Our ref: DOC22/410756

Your ref: SSD-10461

Valley of the Winds Wind Farm – EIS Exhibition

Attachment B - BCS's detailed comments and recommendations

Figure 3 Comparison of EPBC Act Box Gum extent and spatial coverage of informing plots (North)

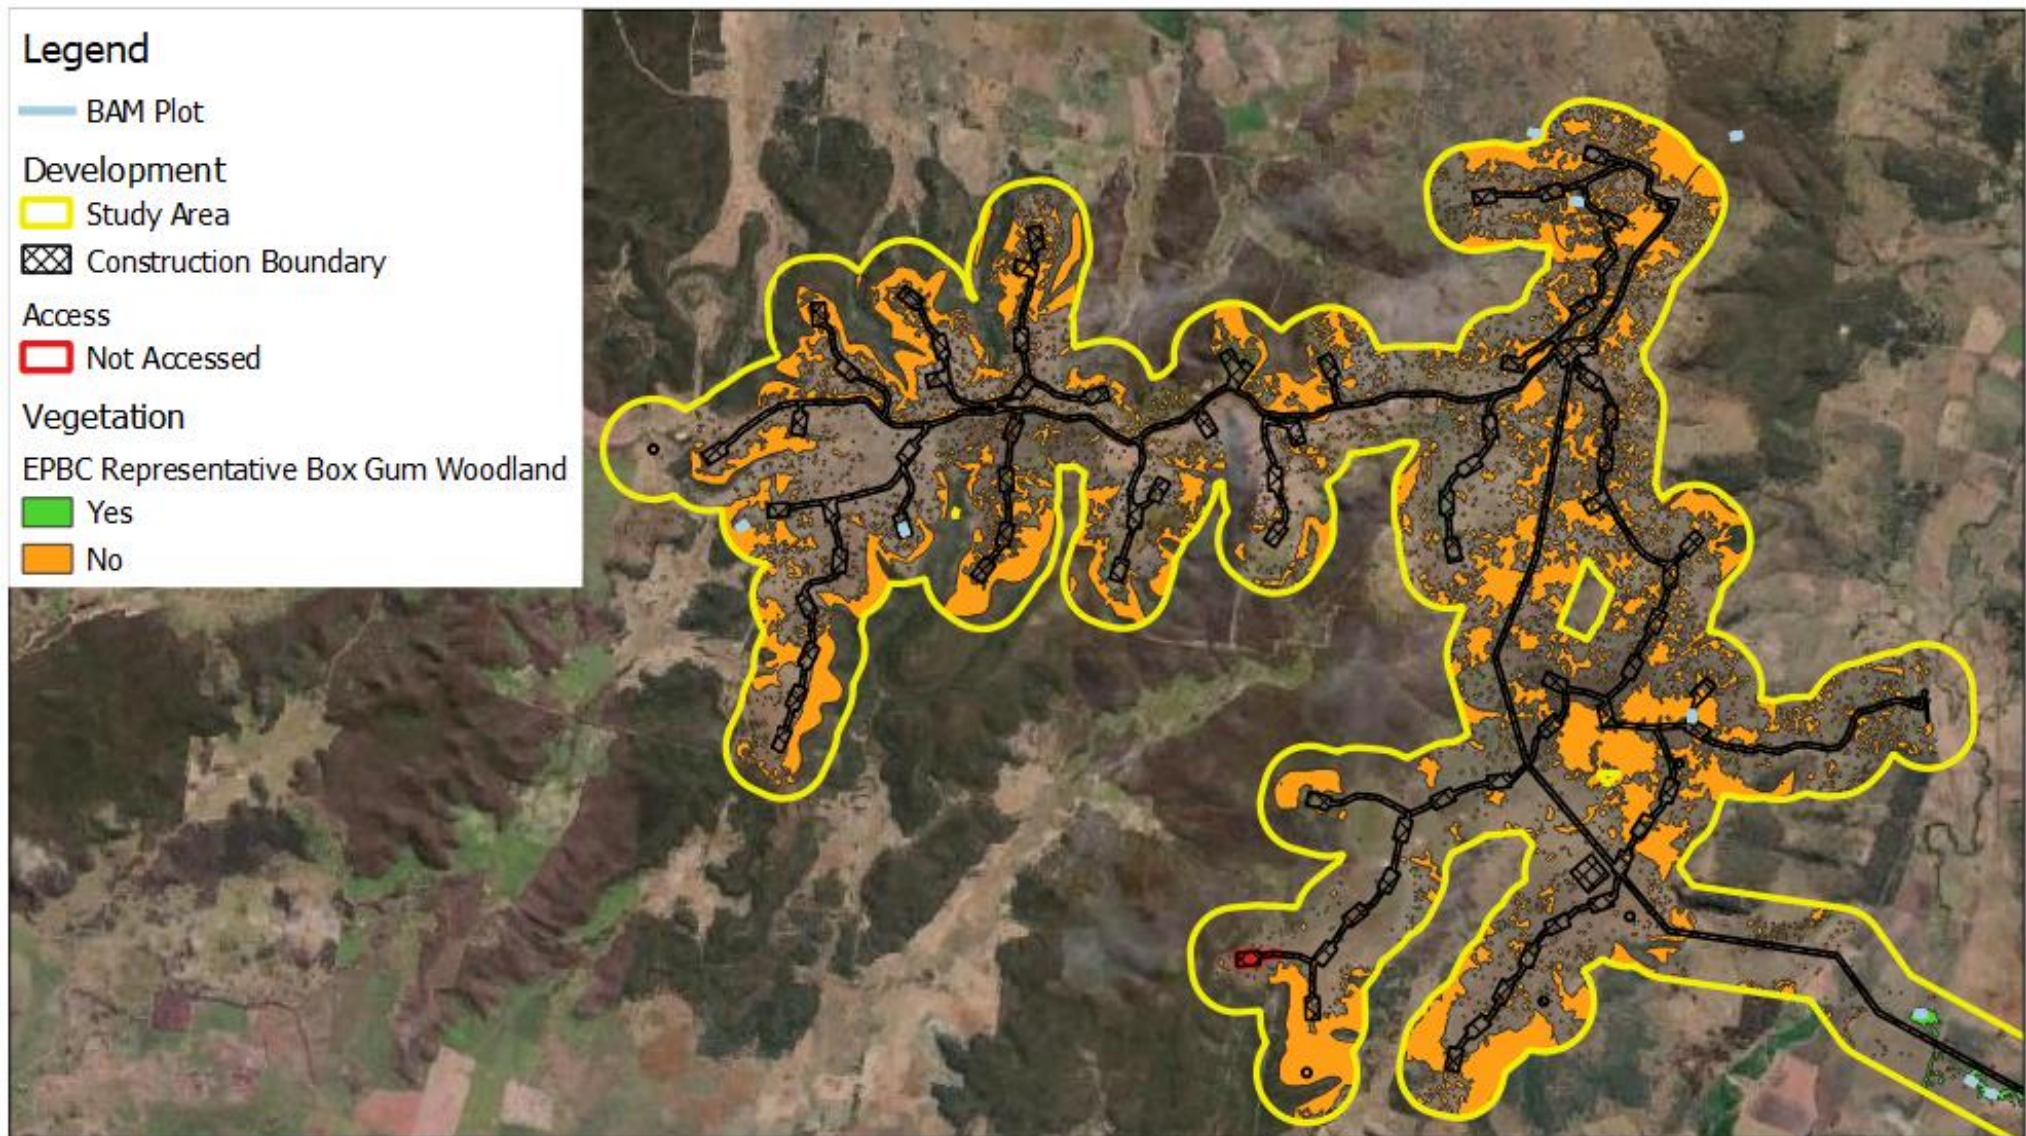
- 11.1 Provide evidence that all vegetation has been appropriately surveyed in detail to inform TEC equivalency assessments and support the determination of non-equivalence to EPBC Act listed TECs.
- 11.2 If evidence has not been collected, assume the presence of the EPBC Act listed TEC.
